Dominion Nuclear Connecticut, Inc.  
Millstone Power Station  
Rope Ferry Road  
Waterford, CT 06385

Millstone Power Station, Unit No. 2  
Technical Specifications Change Request (TSCR) 2-10-01  
Fuel Pool Requirements

Technical Specification Change Request (TSCR) 2-10-01  
Fuel Pool Requirements  
Discussion of Proposed Changes and Safety Summary

FIGURE 3.9-1A MINIMUM REQUIRED FUEL ASSEMBLY EXPOSURE AS A FUNCTION OF INITIAL ENRICHMENT TO PERMIT STORAGE IN REGION C

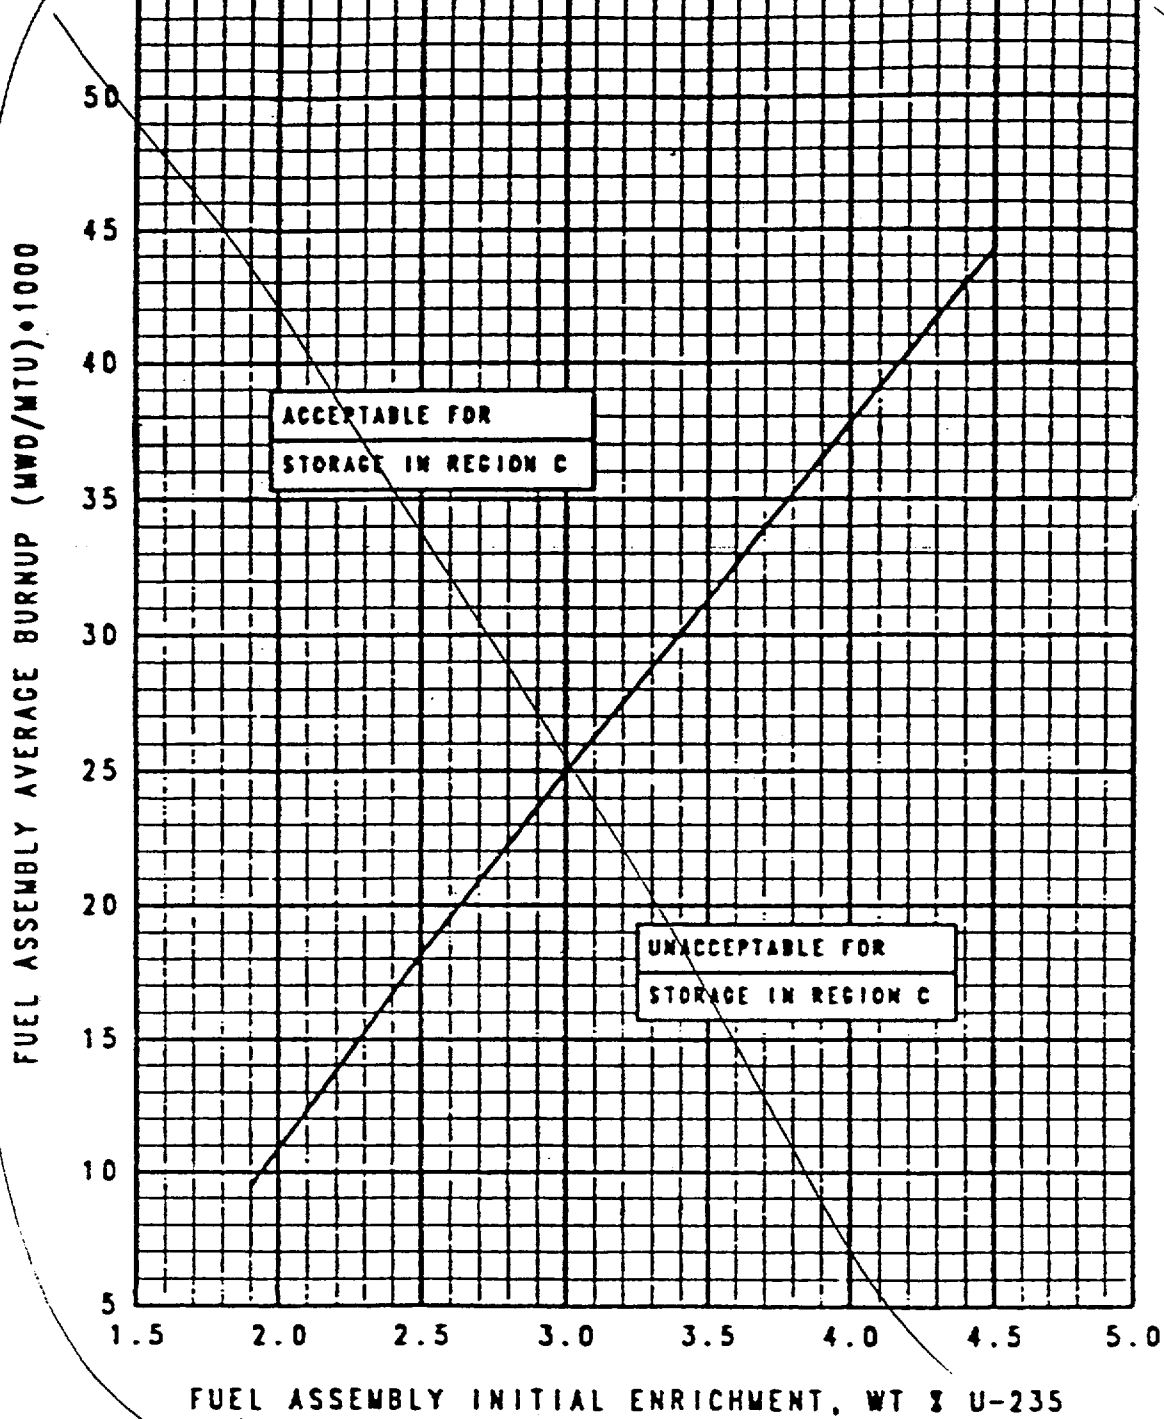
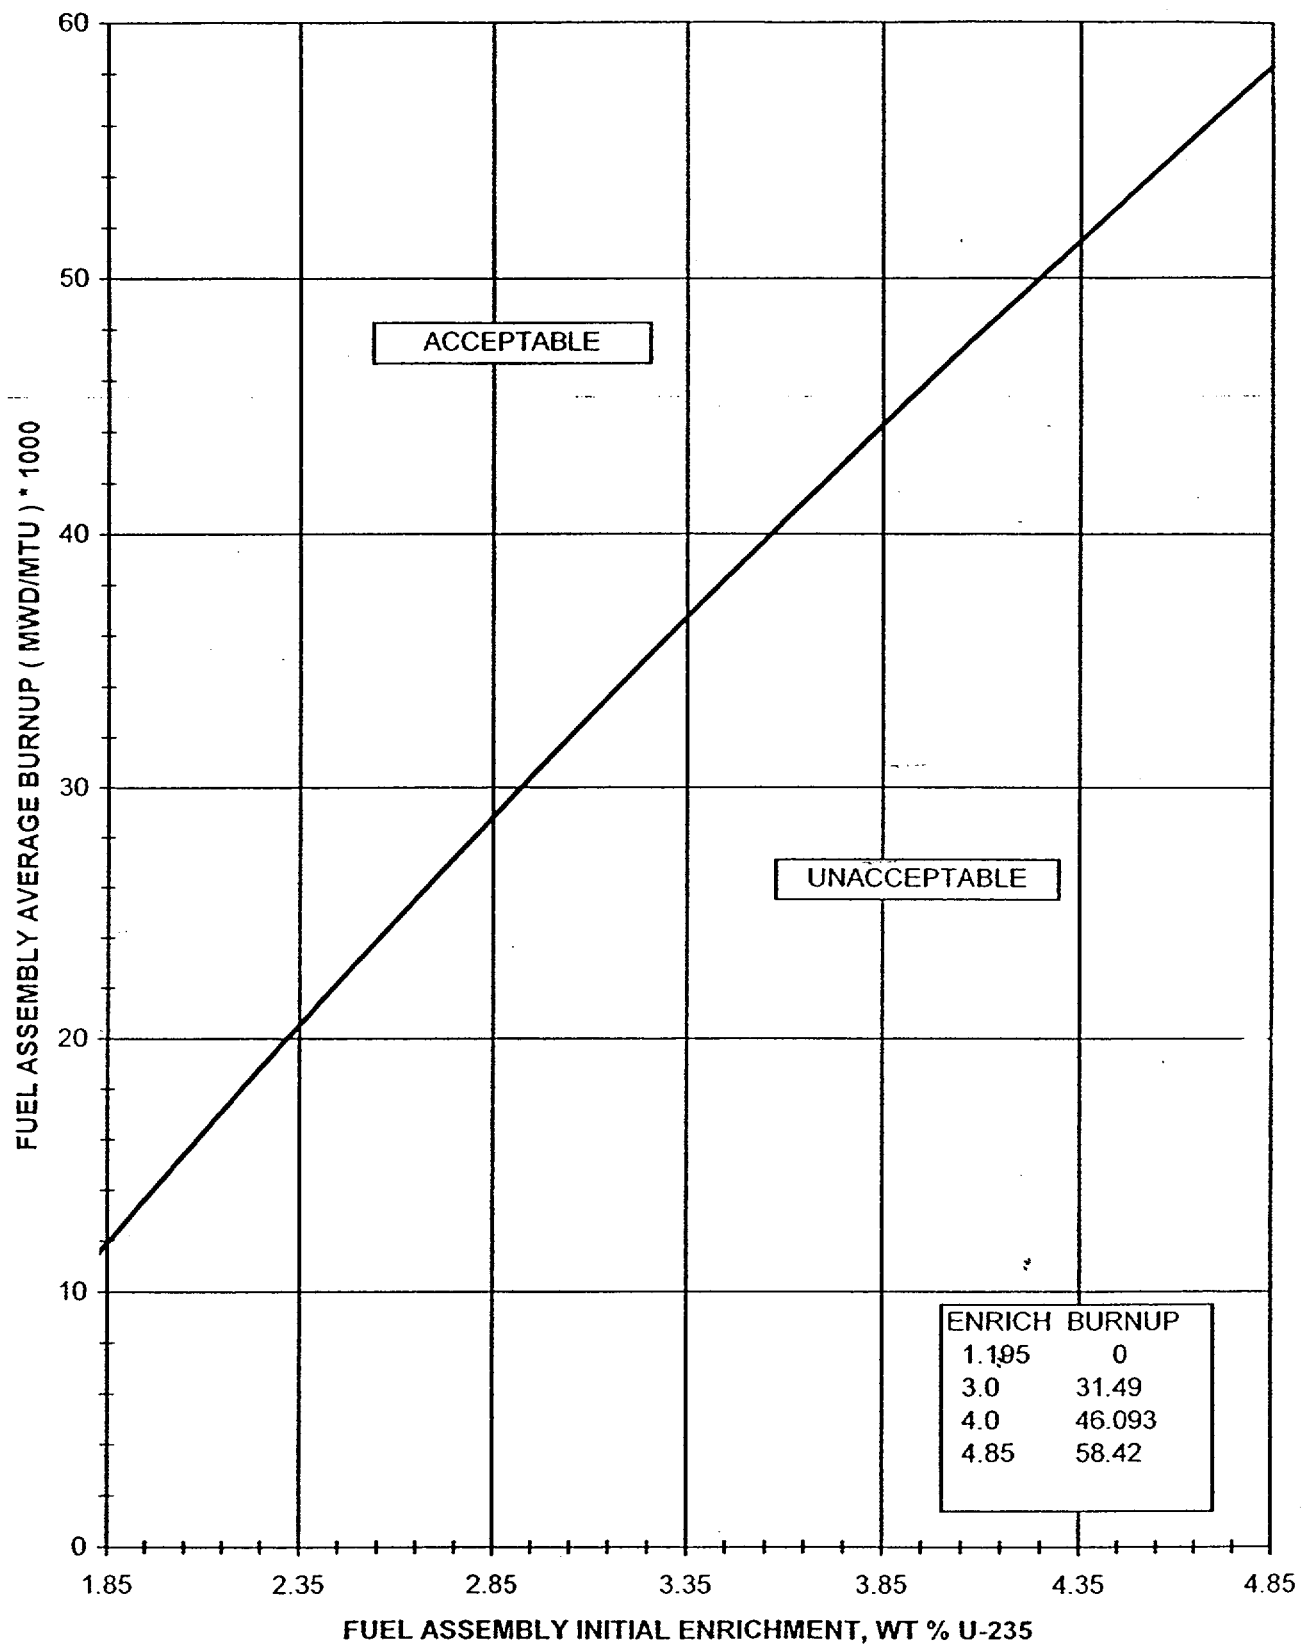
This TS figure shows the minimum required fuel assembly exposure as a function of initial enrichment to permit storage of fuel assemblies in Region C. This TS figure is revised to reflect the revised criticality analysis.

The values shown in this Figure are taken from the criticality analysis that is attached. The required burnups shown in the proposed Figure 3.9-1A are slightly smaller than the current limits due to soluble boron credit.

SPENT FUEL POOL ARRANGEMENT  
FIGURE 3.9-2  
(NOT TO SCALE)

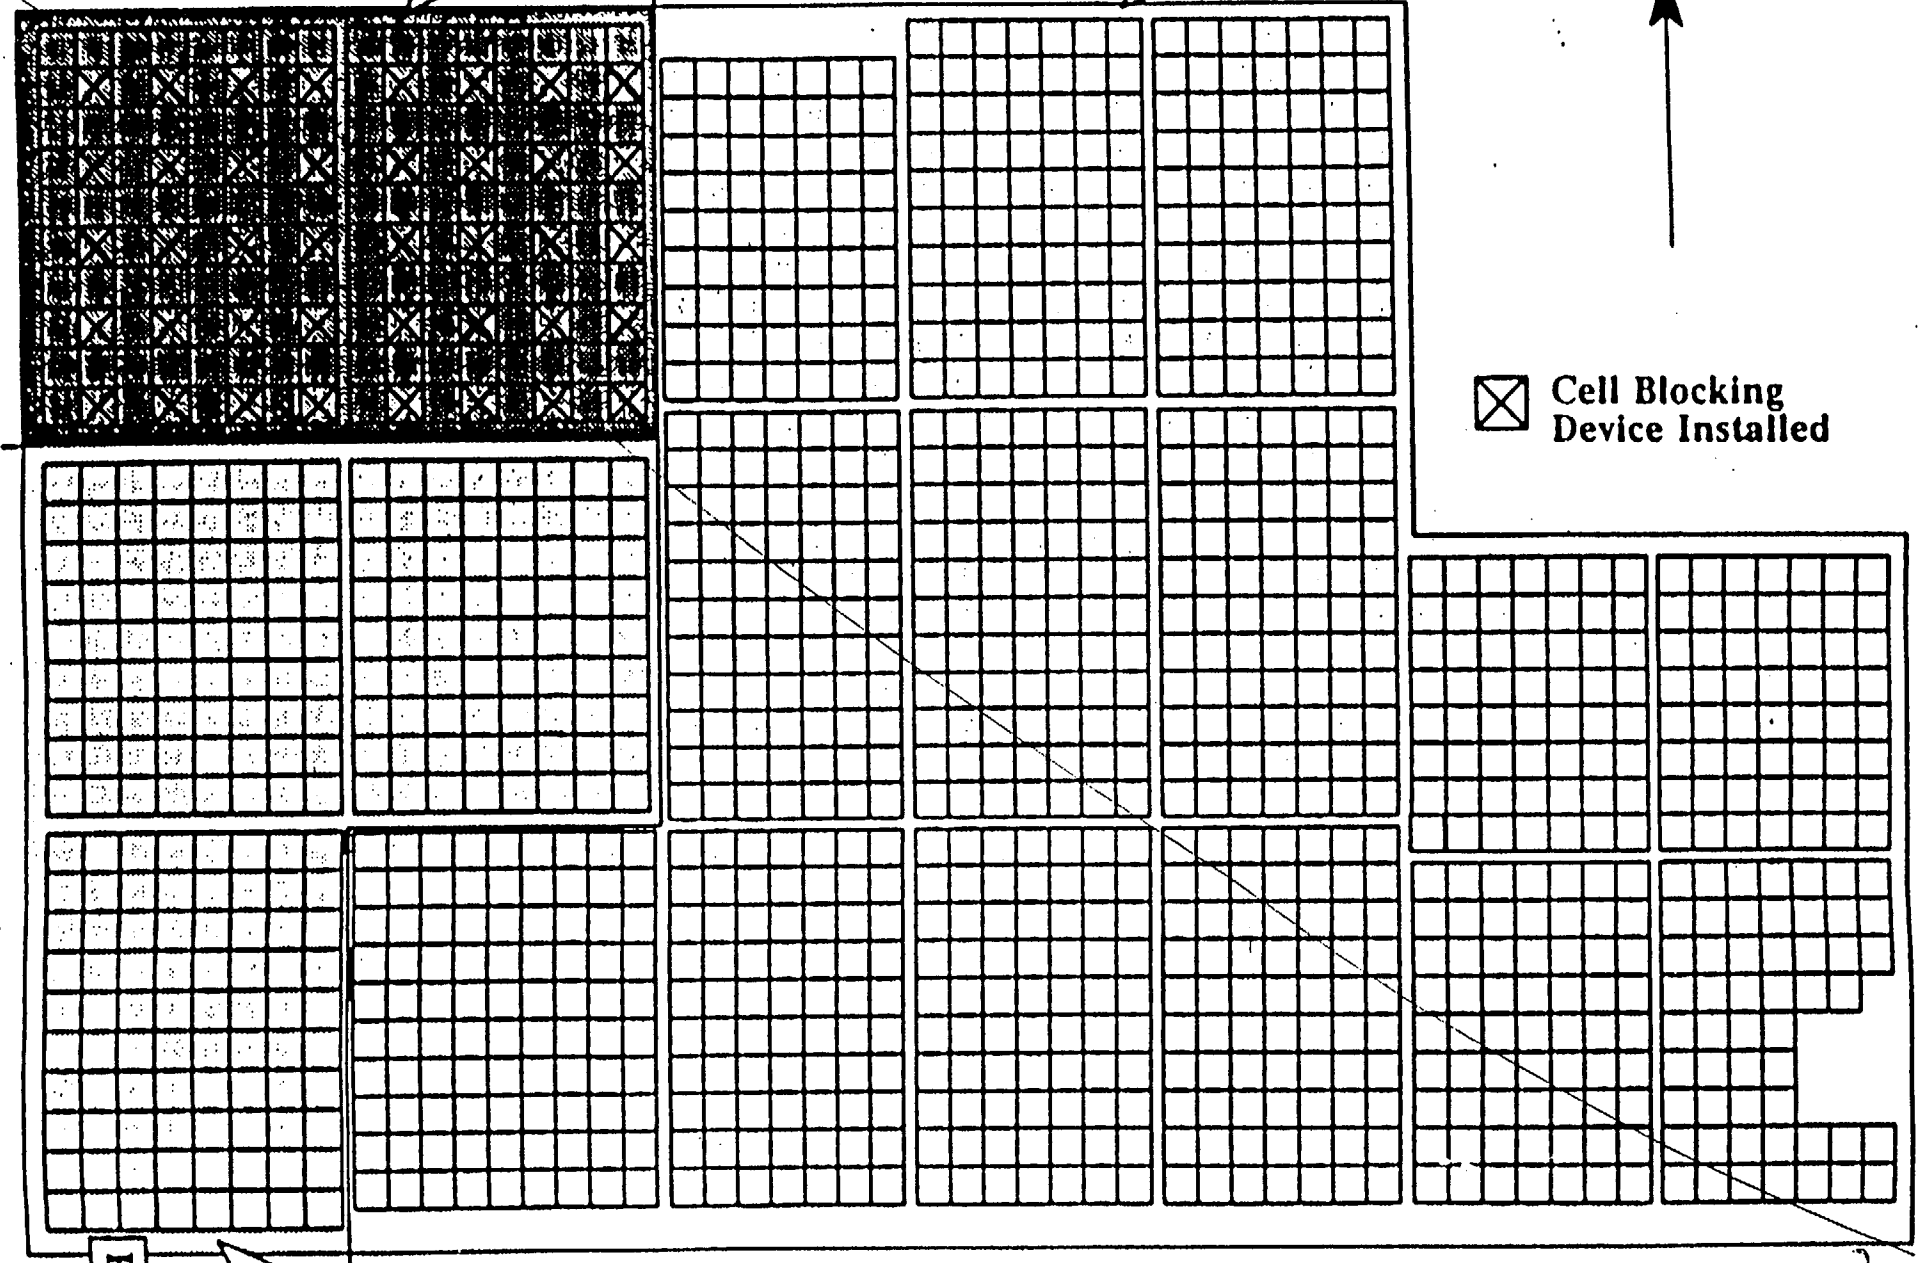
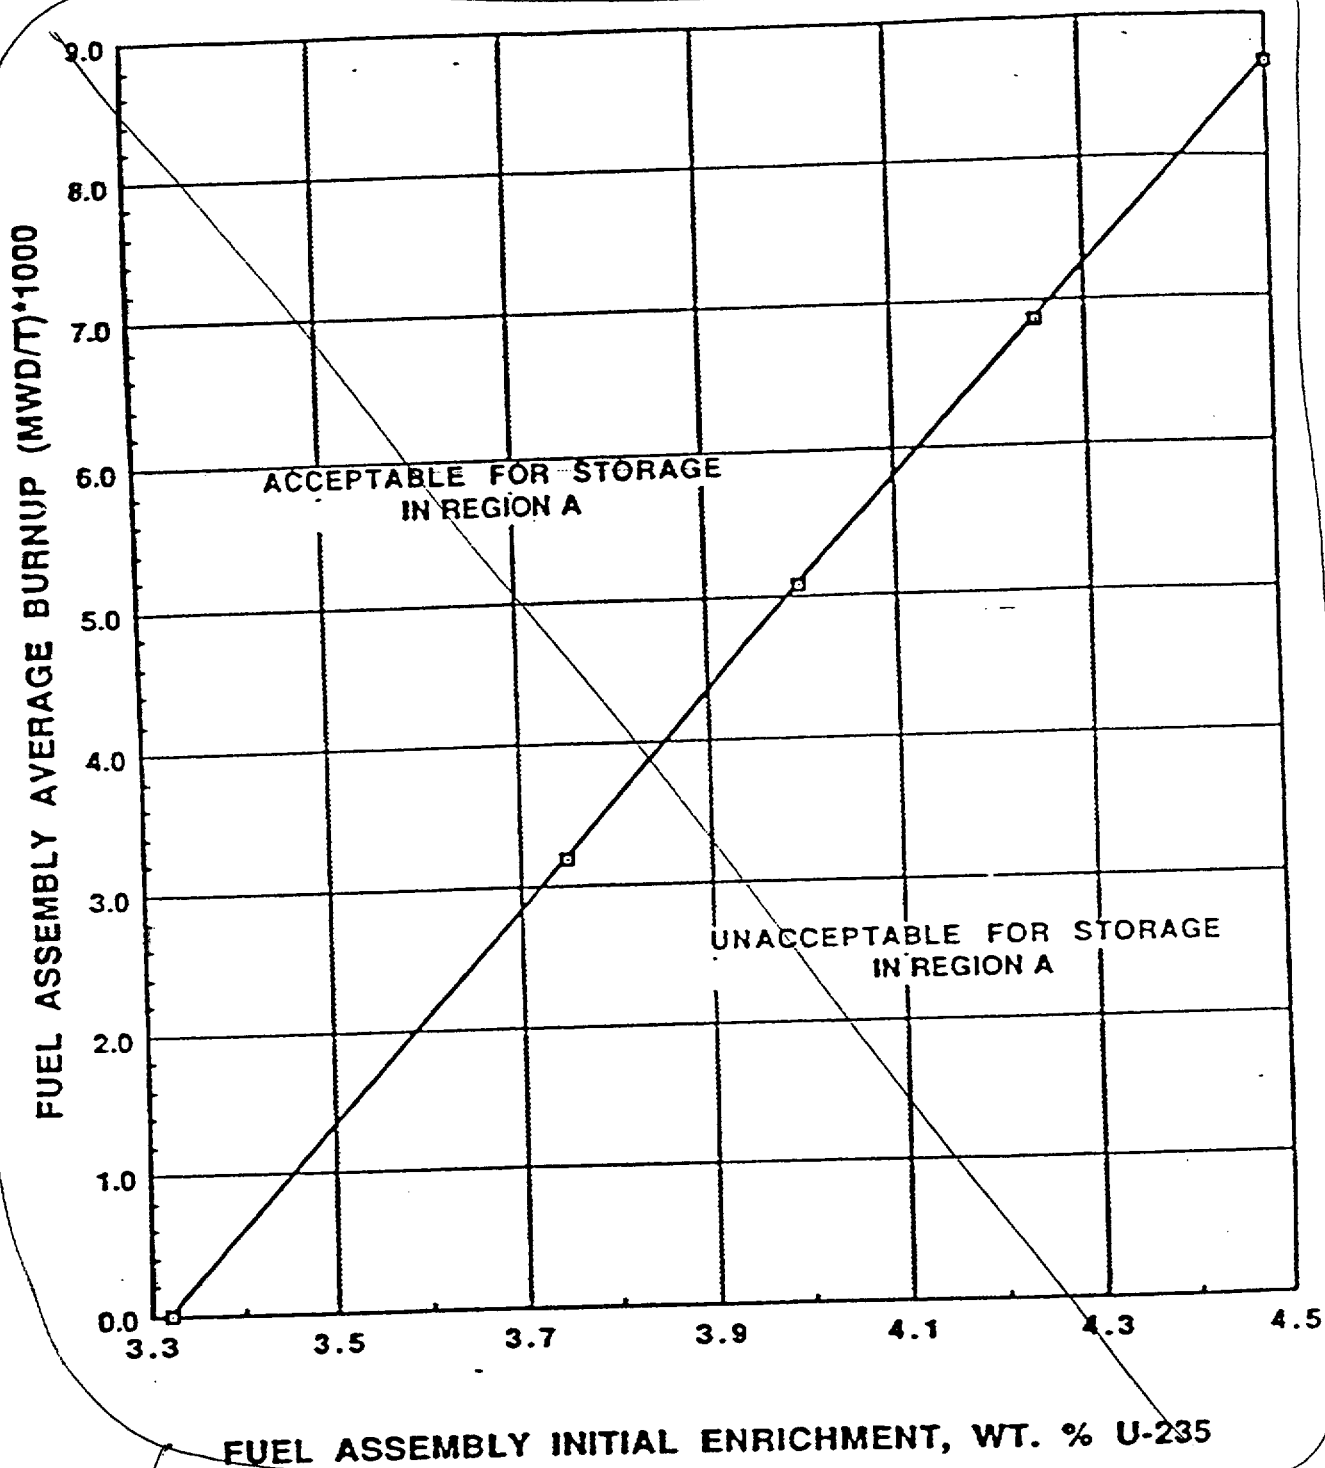
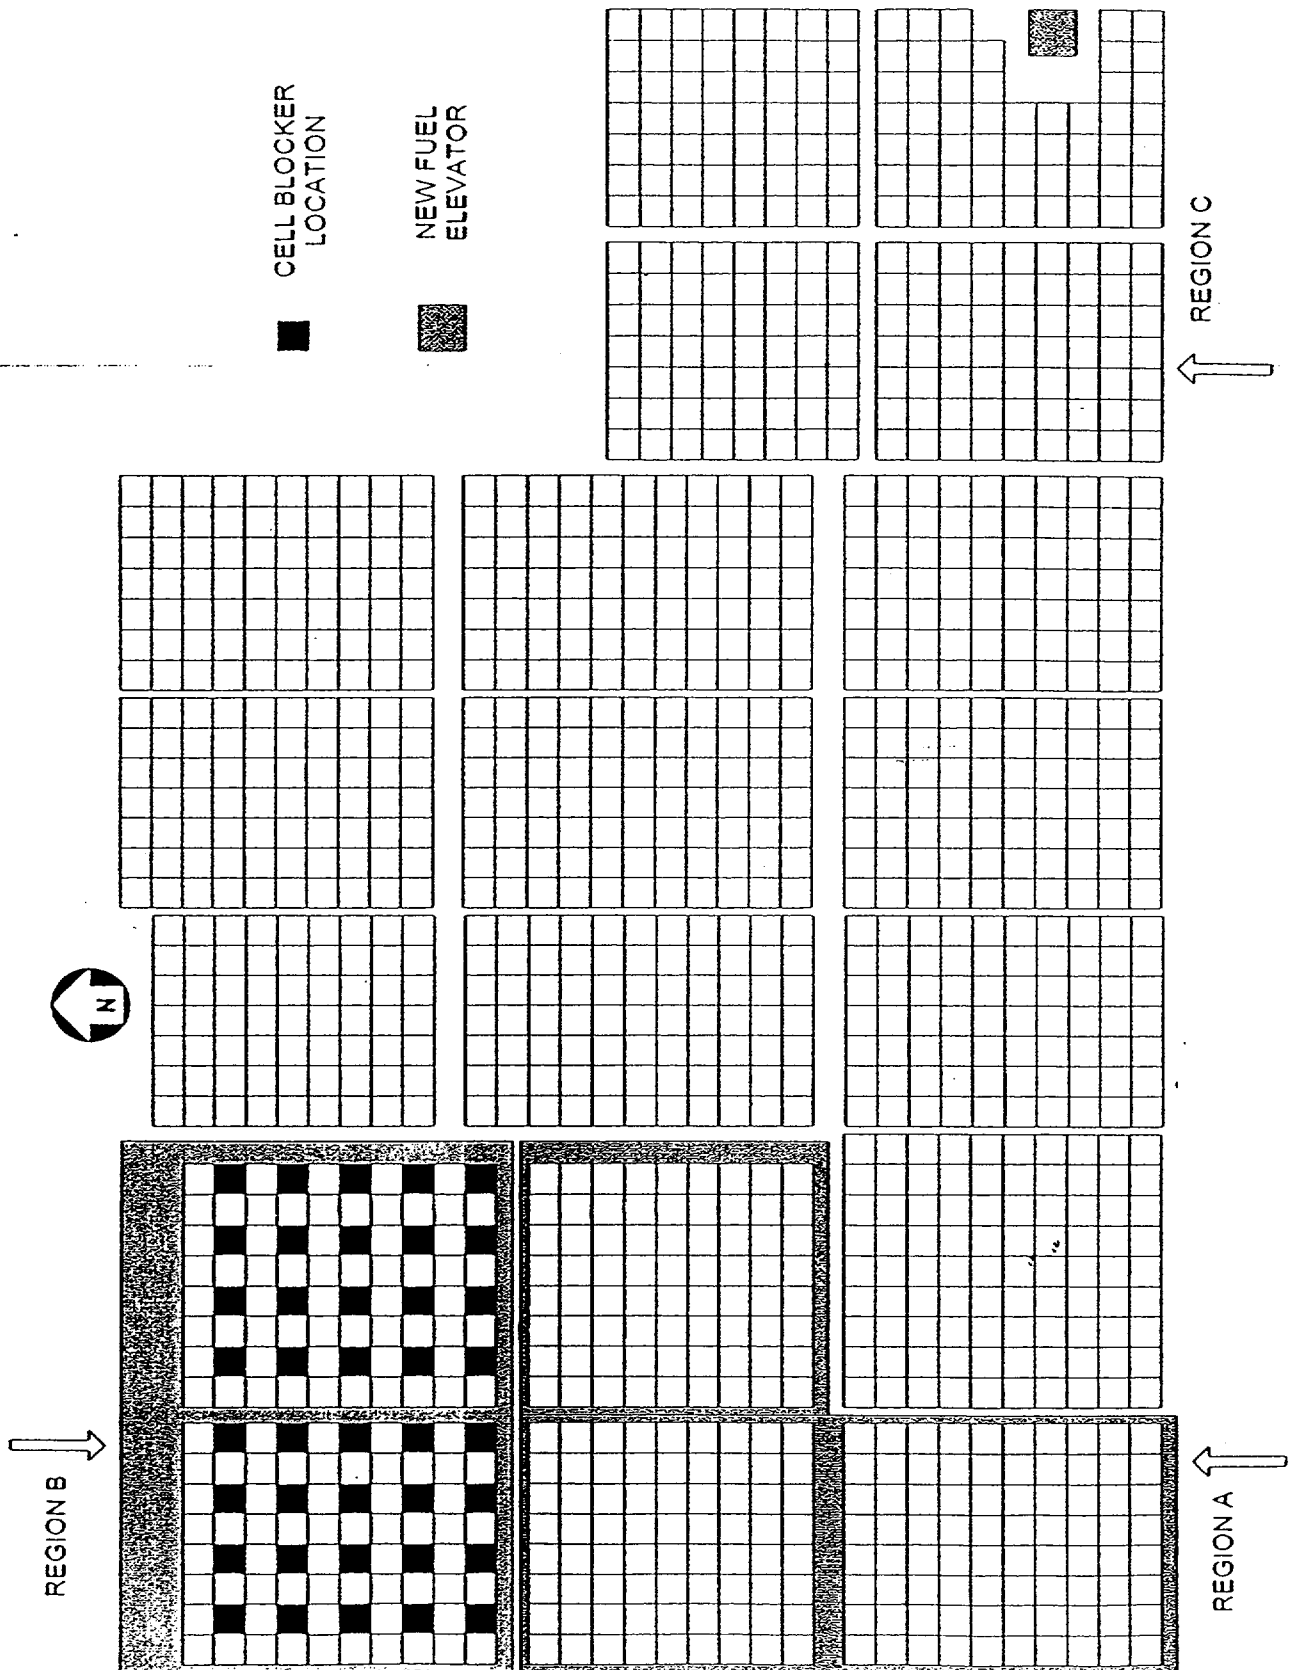
This proposed TS figure is revised only to provide a clearer Figure to show the spent fuel pool arrangement. There are no changes to the Figure.

3.9.19(1) is revised to add a sentence acknowledging that a Batch B fuel assembly may be stored underneath the cell blocker. 3.9.19(2) is revised to state that if a cell blocker is removed, all cells except the location with the removed cell blocker device must be vacant of fuel. This acknowledges that storage of a fuel assembly in the cell blocker location is now possible.
